**ANC 3C Resolution No. 2015-021**  
**Regarding DDOT Public Space Application to Install a Fence for the**  
**Vatican Embassy, located at 3339 Massachusetts Avenue, NW**

## Memorandum

**SUBJECT:** FMBZA 19013 –Application of the Apostolic Nuncio of the Holy See, pursuant to 11DCMR § 1002 and §206 of the Foreign Missions Act

**SUBJECT:** FMBZA Case No. 19013 – Vatican Embassy

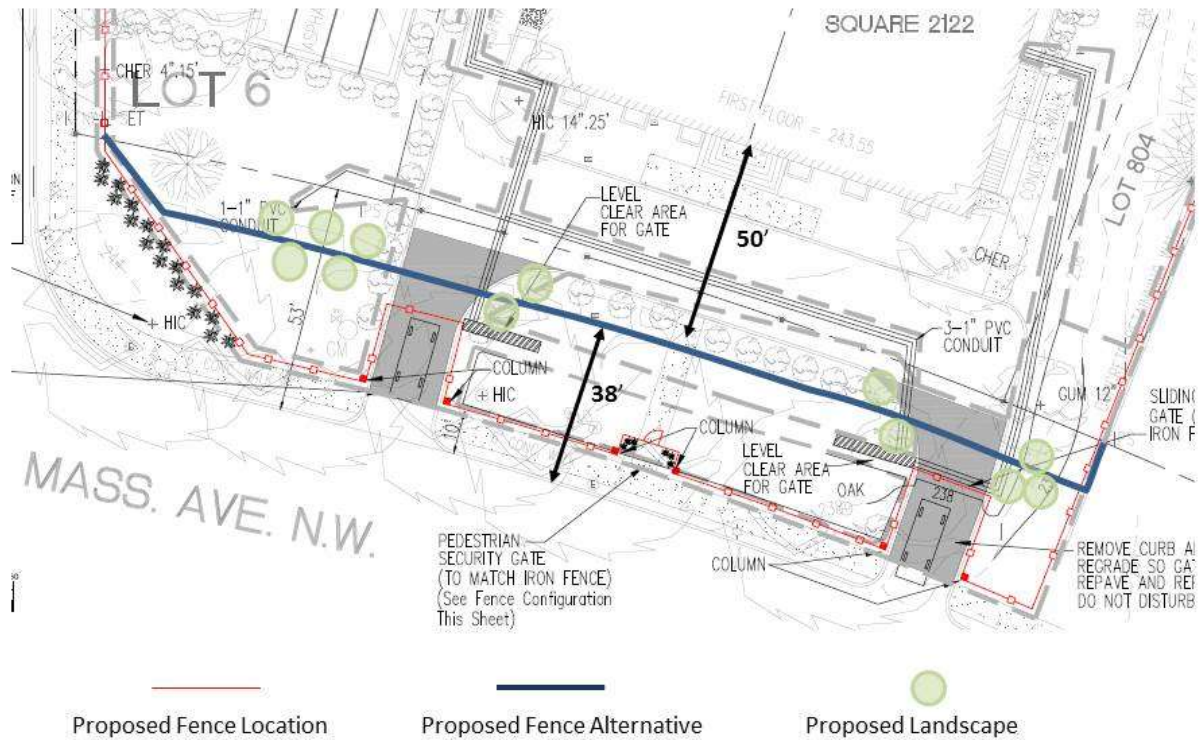
located three feet from the back of the sidewalk, behind hedges, and within a building restriction area. Along Massachusetts Avenue, the fence is proposed to be in public space. The fence's visual impact along Massachusetts Avenue, where the embassy is set back more than 80 feet from the curb, is notable. In this location, the fence impacts the view corridor along the Avenue, where it is proposed to be eighteen inches from the back of the sidewalk. While the fence along 34<sup>th</sup> Street also requires a waiver from regulations, its location behind landscaping mitigates its impact on public space.

The proposed security buffer (the distance between the proposed fence and the building) along Massachusetts Avenue also exceeds the 50-foot security setback for Level IV facilities, recommended by the U.S. Department of Homeland Security's Interagency Security Committee (ISC) and adopted in August 2013.<sup>4</sup> Foreign embassies and consulates in the United States are identified as Level IV facilities. The embassy main building is 35 feet from the property line and more than 80 feet from the curb, leaving a generous amount of set back from the building to where a security fence providing the security buffer could be located. A security fence pulled back closer to the property line, as far as 38 feet from the curb, would maintain the 50 distance from the embassy and be more consistent with the intent of public space regulations - see alternative fence location, Attachment III, developed by OP Staff. Historic Preservation Review staff indicated that they do not object to the alternative location. OP contacted the representative of the applicant to request a meeting to discuss the alternative, but the request was declined.

The Office of Planning, therefore, has no concerns with the proposed design, materials, or height of the proposed security fence and gates, but concludes that it would be made more consistent with District interests in maintaining the open character along Massachusetts Avenue and maintaining the health of street trees by placing the fence up to 38 feet back from the curb. This would also satisfy U.S. Department of Homeland Security criteria and embassy needs for the standard 50 foot security buffer between the fence and the building.
